**ADDENDUM NO. 1  
TO CONTRACT DOCUMENTS FOR THE  
PERMANENTE CREEK FLOOD PROTECTION PROJECT-  
CHANNEL IMPROVEMENTS  
Project No. 26244001; Contract No. C0625**

**ADDENDUM NO. 1  
PERMANENTE CREEK FLOOD PROTECTION PROJECT  
CHANNEL IMPROVEMENTS**

**REPLACE** in their entirety the following drawings (**ATTACHMENT 5**):

FLOOD CONTROL INTERNATIONAL  
PROPOSAL DRAWING

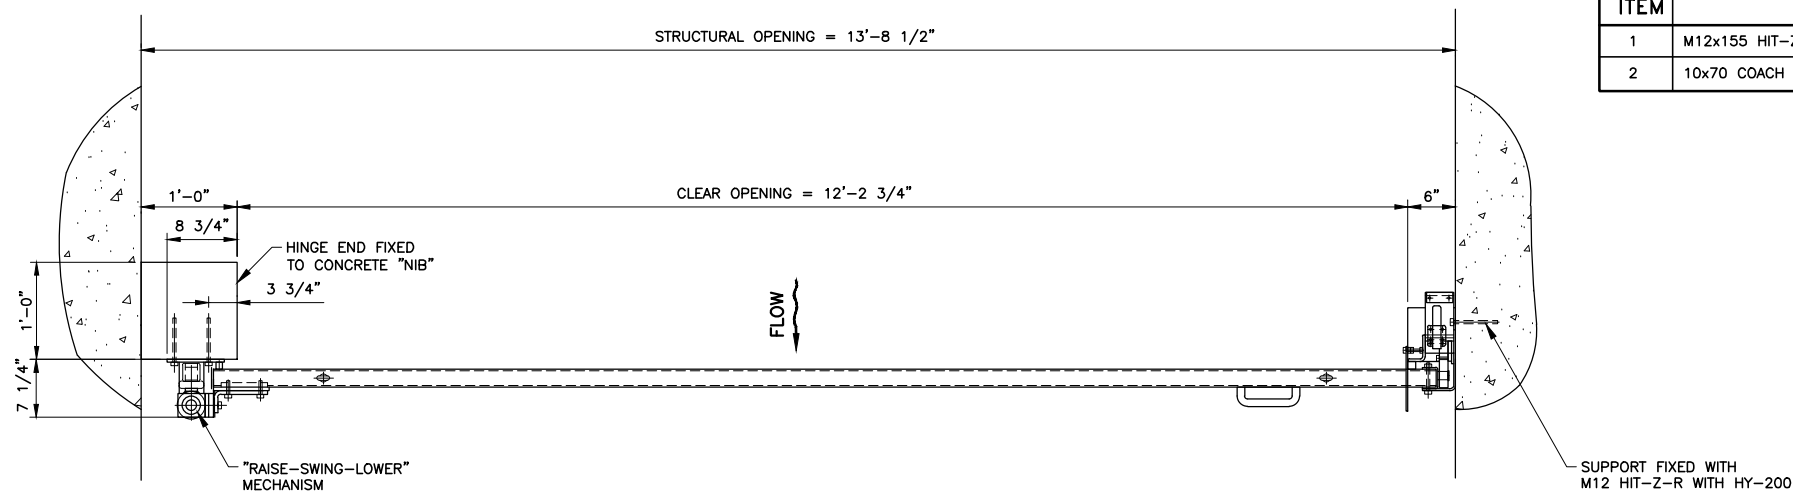
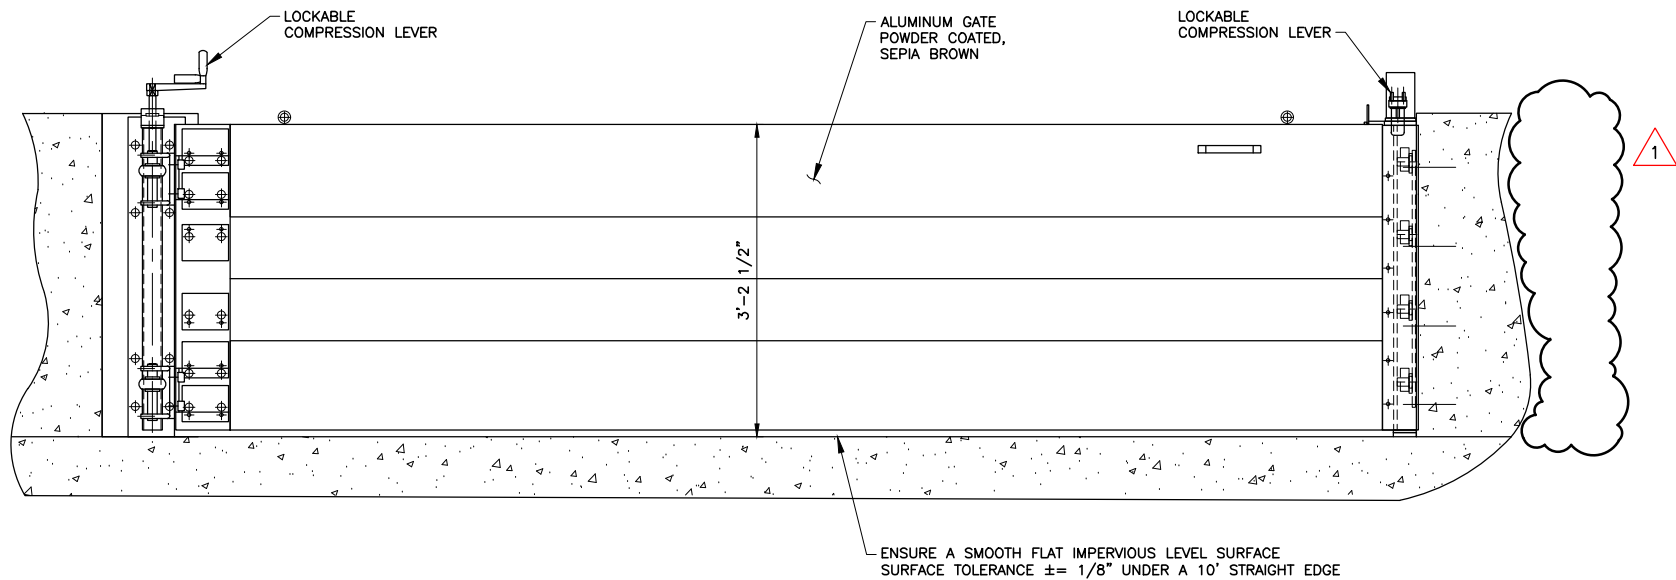
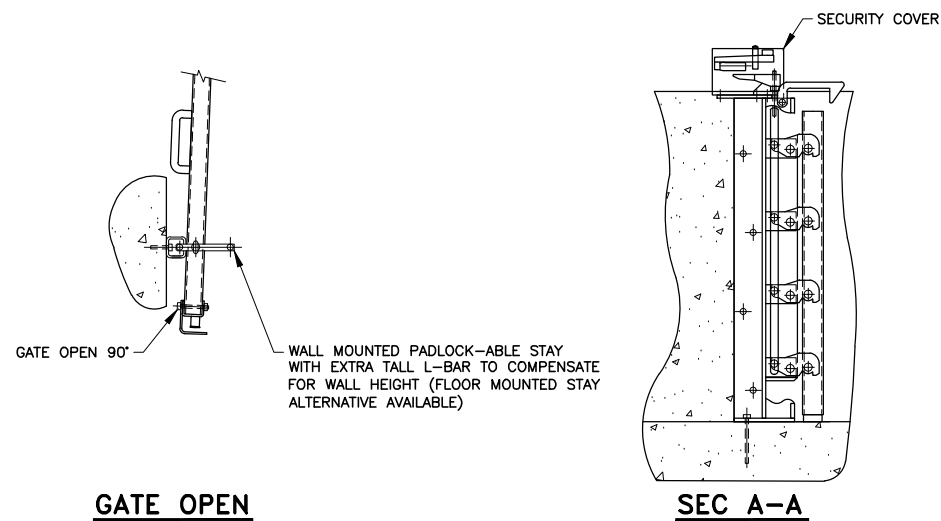
Response 7	Please adhere to the Schedule of Work as stated in Specifications Section 11.
Question 8	On Sheet C-6 on the Profile Scale at C/L Station 11+86 indicates the Flood Gate to be approx. 3' 10" in height with no indication of a footing. Also on C-6 on the Plan Scale at C/L 11+86 it shows what it appears to be a ramp on the armor aggregate side but has no details. On Sheet S-14 it indicates the Flood Gate to be 3' 4" in height with indication a footing. Please clarify with further details.

Response 8	Please refer to Article 24.11, Armoring Aggregate, of the Project Specification and Addendum No. 2, Drawing Sheets C-6 and S-14, the floodgate wall height shall be a minimum of 3' based on C-6. Drawing Sheet S-14 is a proposal drawing and the floodgate shall be installed in accordance with the manufacturer's recommendations and related sections of the contract documents.

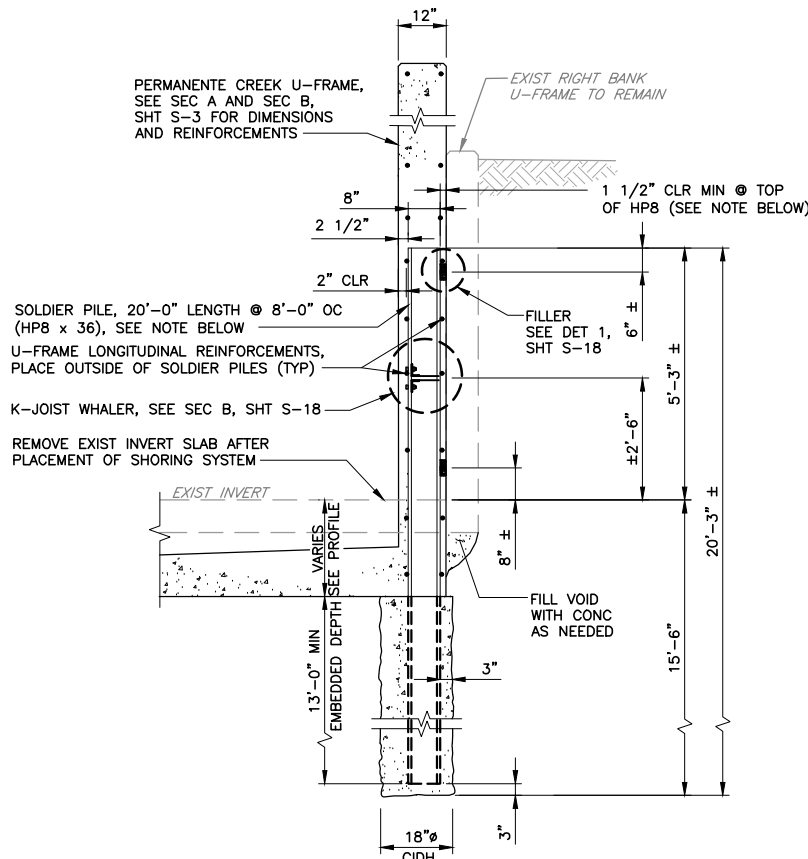
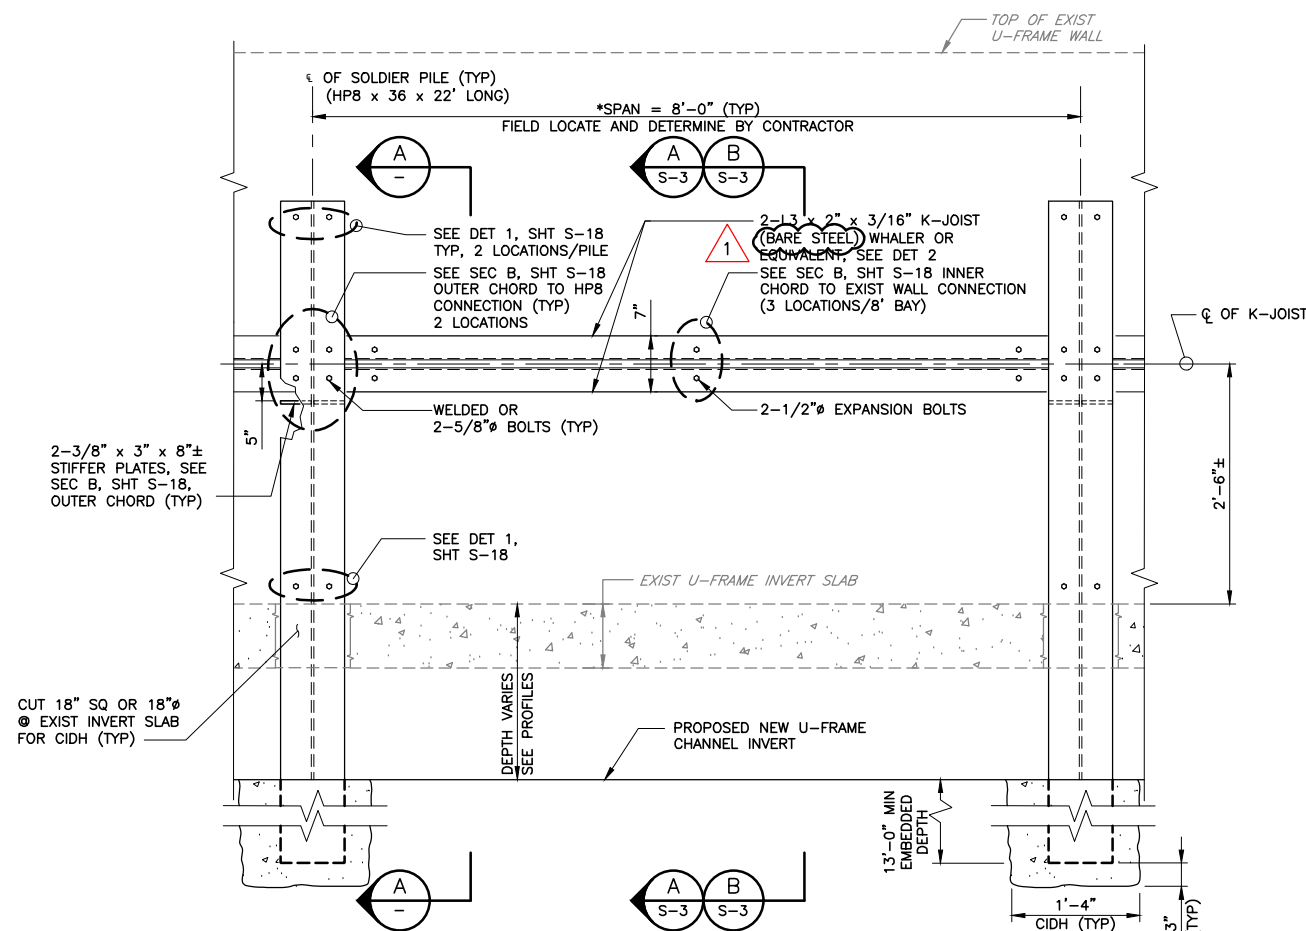
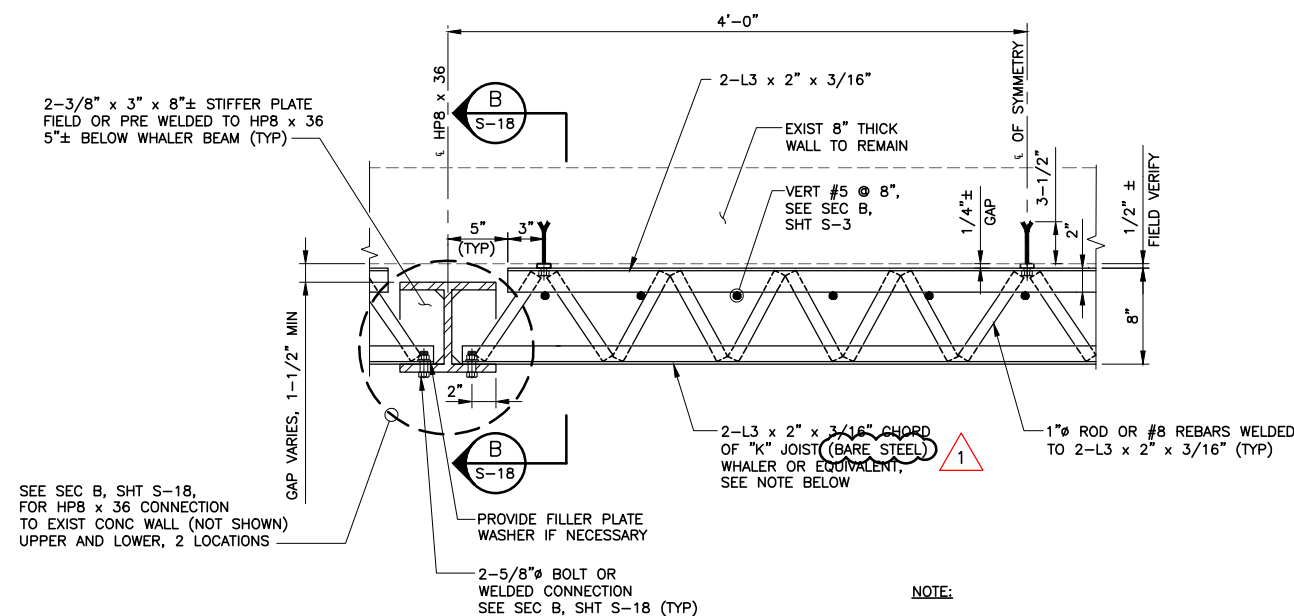
Question 32	Do the I-beams used in the special shoring system in Permanente Creek need to be hot dipped galvanized (HDG). Ref. Sheet S-17.
Response 32	No, the I-beam is not required to be galvanized. Please refer to Article 26.04, Paragraph B-12 of the Project Specifications.

Question 33	Does the note on the "K" joist (B.S.) mean that they are black steel or bare steel? Ref. Sheet S-17.
Response 33	It should be bare steel. Please refer to this Addendum No. 2, Detail 2, SHT S-17.
